## Addendum Number 1

**JAMES C. ARCHIE ROAD RECONSTRUCTION PROJECT**  
Southern University and A&M College  
Baton Rouge, Louisiana 70813

**Addendum No. 001**

**James C. Archie Road Reconstruction Project**

002

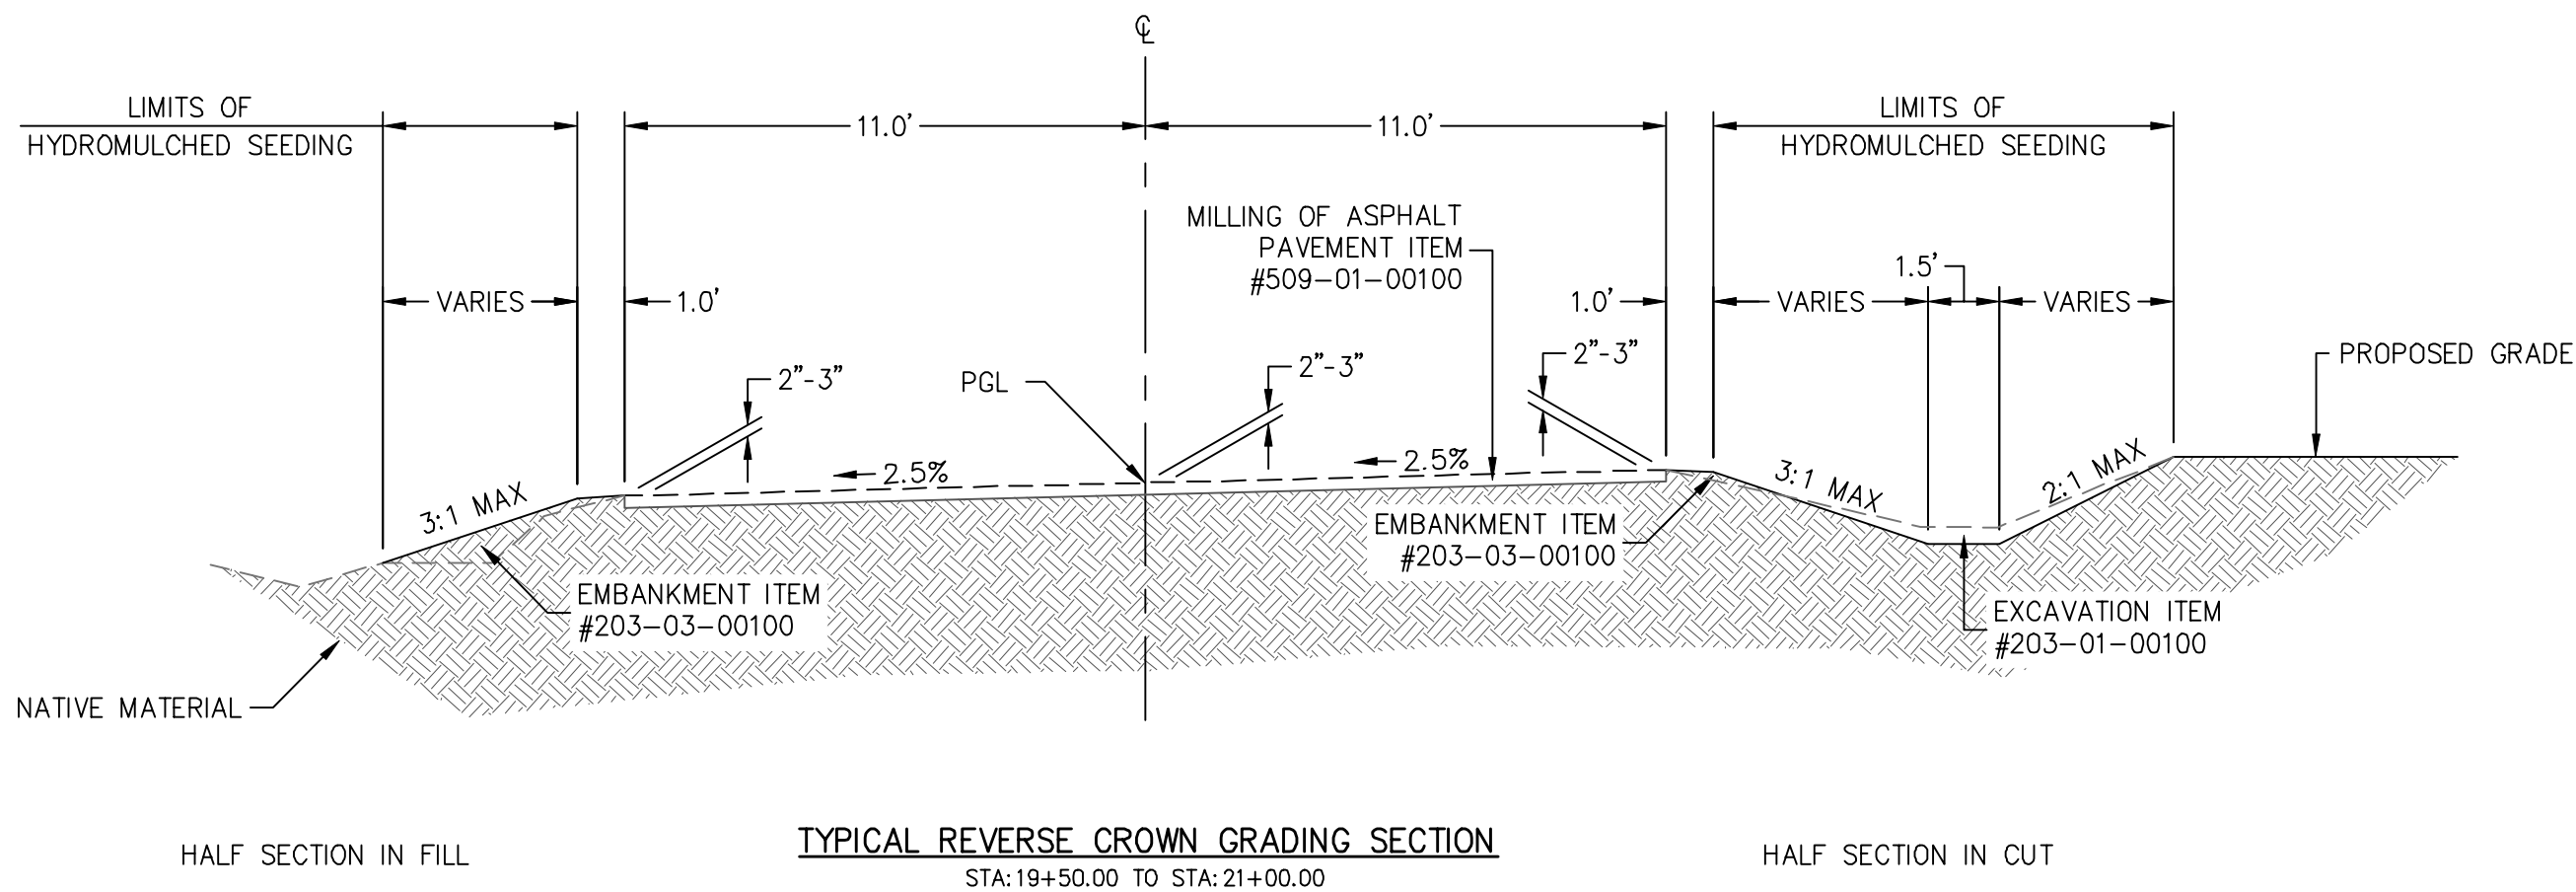
**a. Sheet Number 002**

i. General Note 4 to be revised to state: Cement rate is for bidding purposes only. Owner shall determine the required cement rate in accordance with LSSRB 303.02.1.2.

**007**

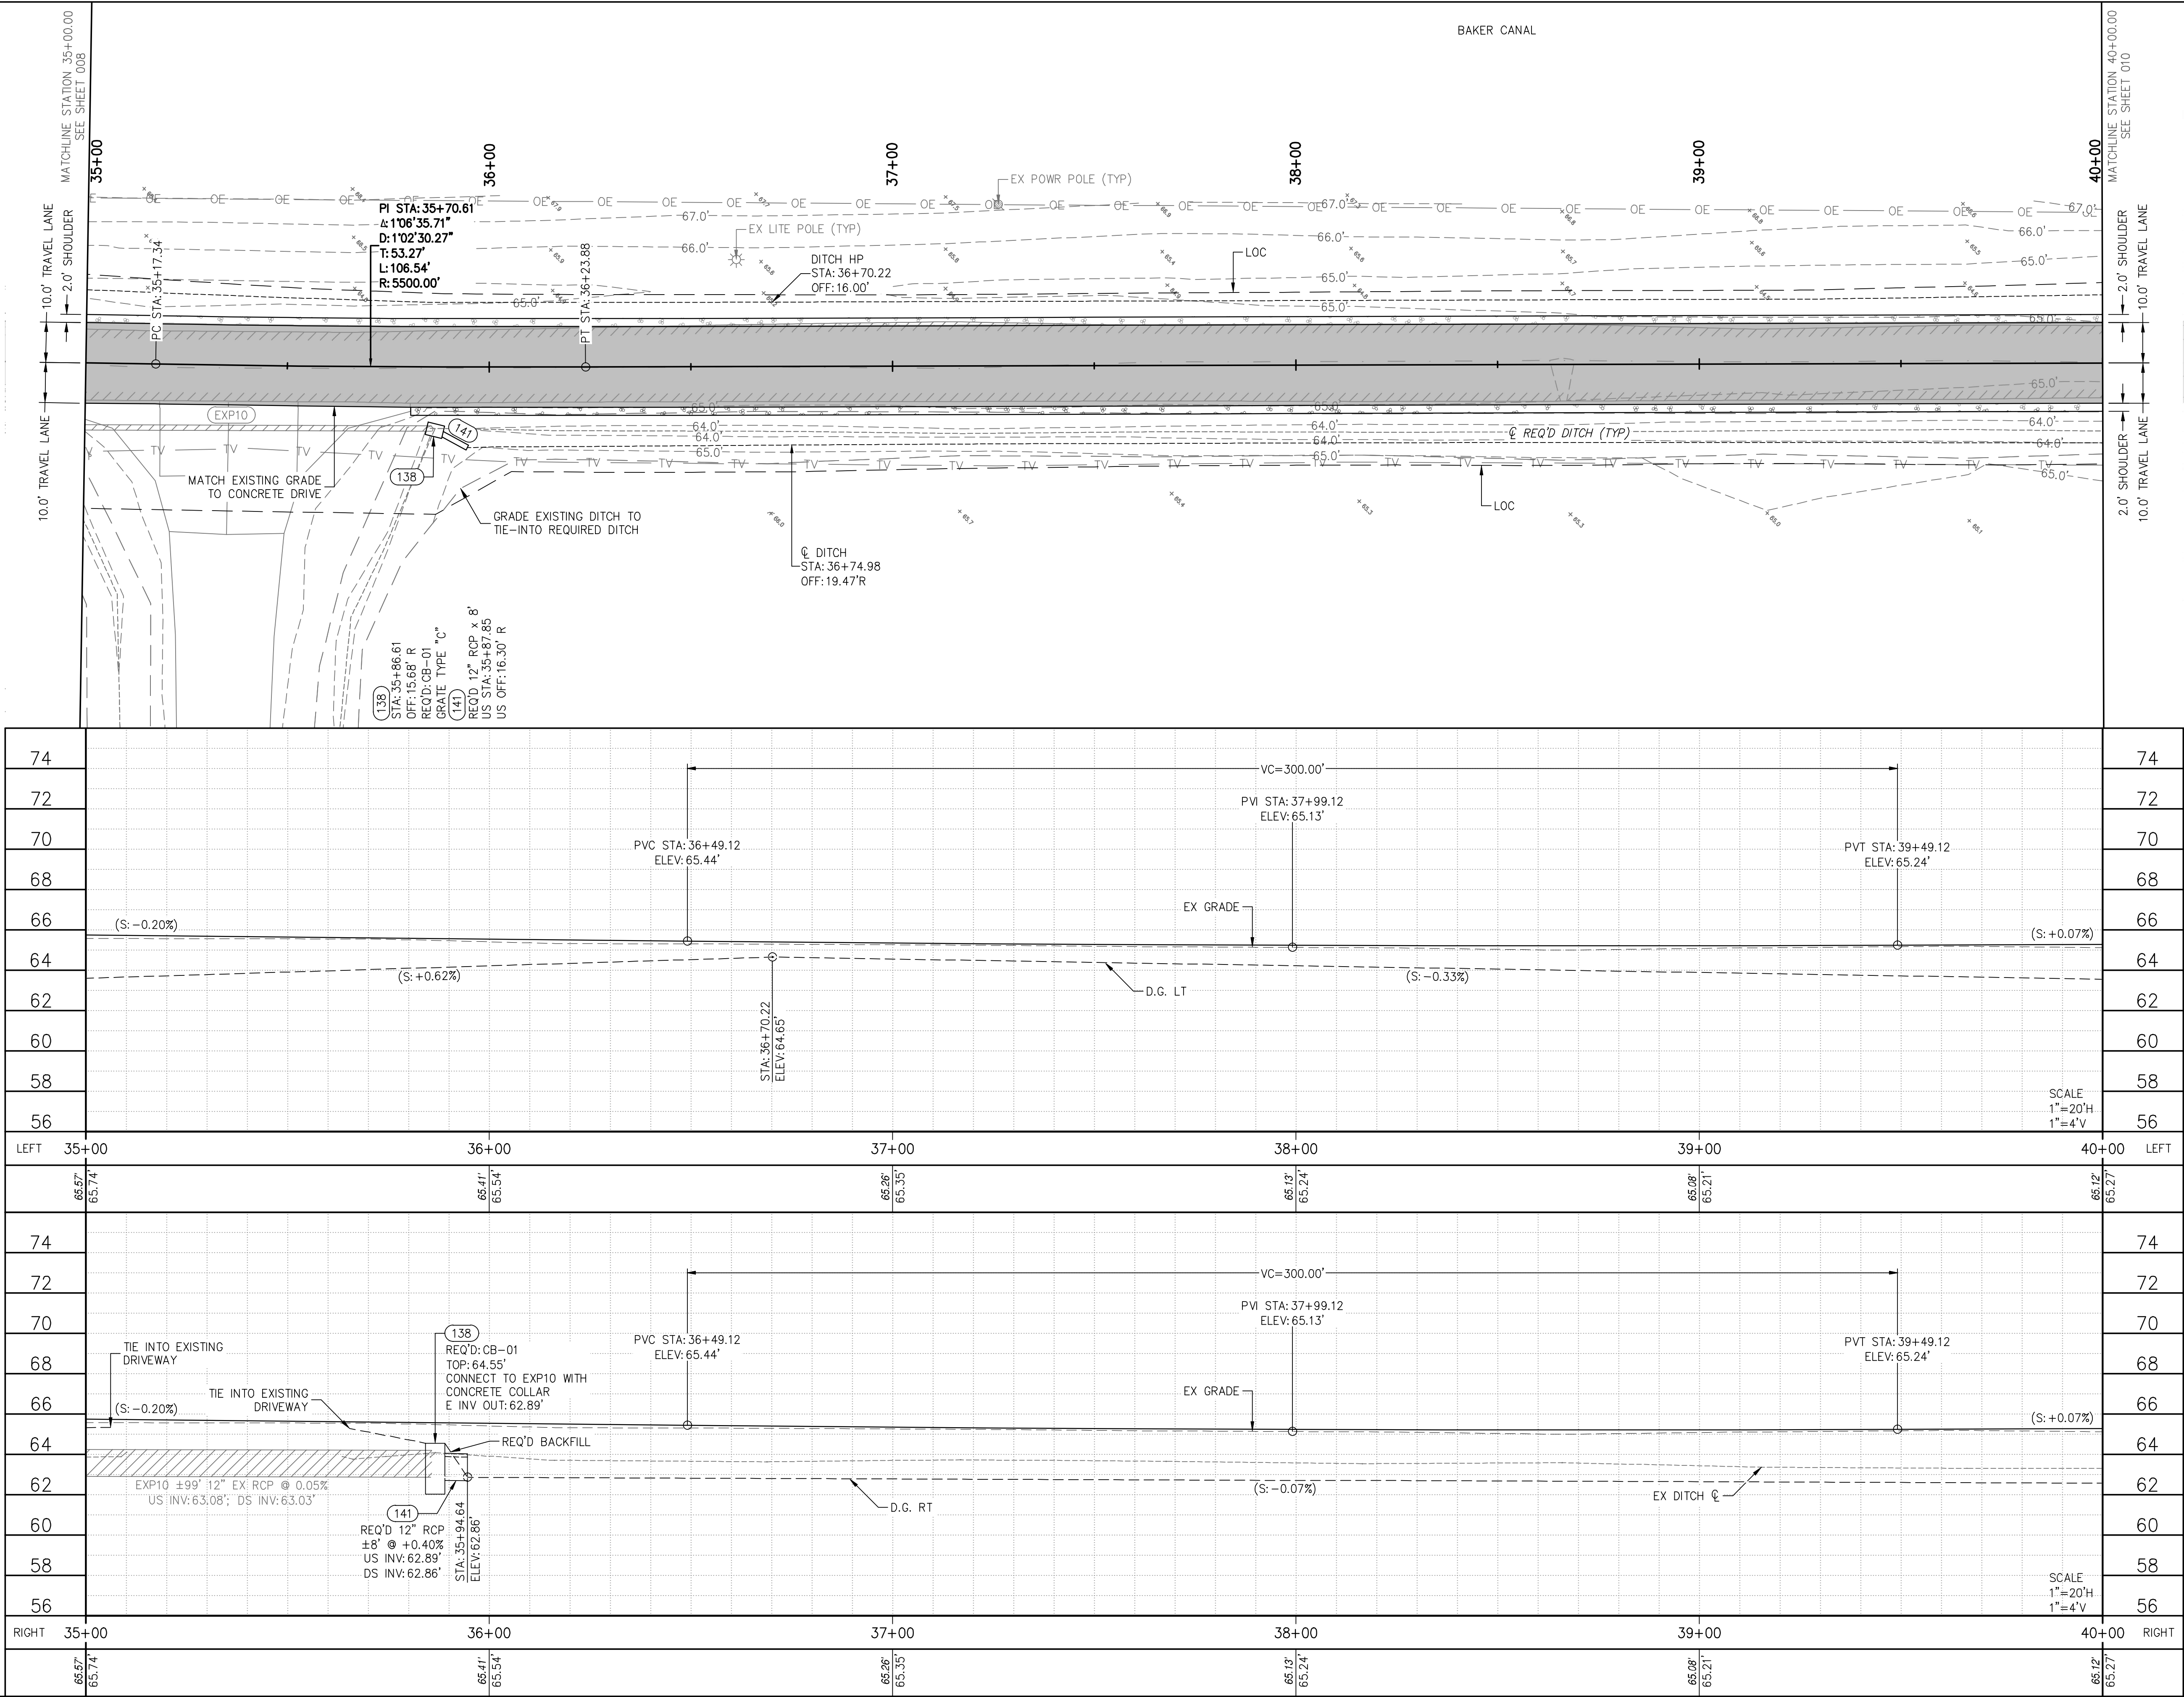
**c. Sheet Number 007**

i. Leader “EX 60” PECAN TREE TO BE REMOVED” to be revised to “EX 60” OAK TREE TO BE REMOVED”
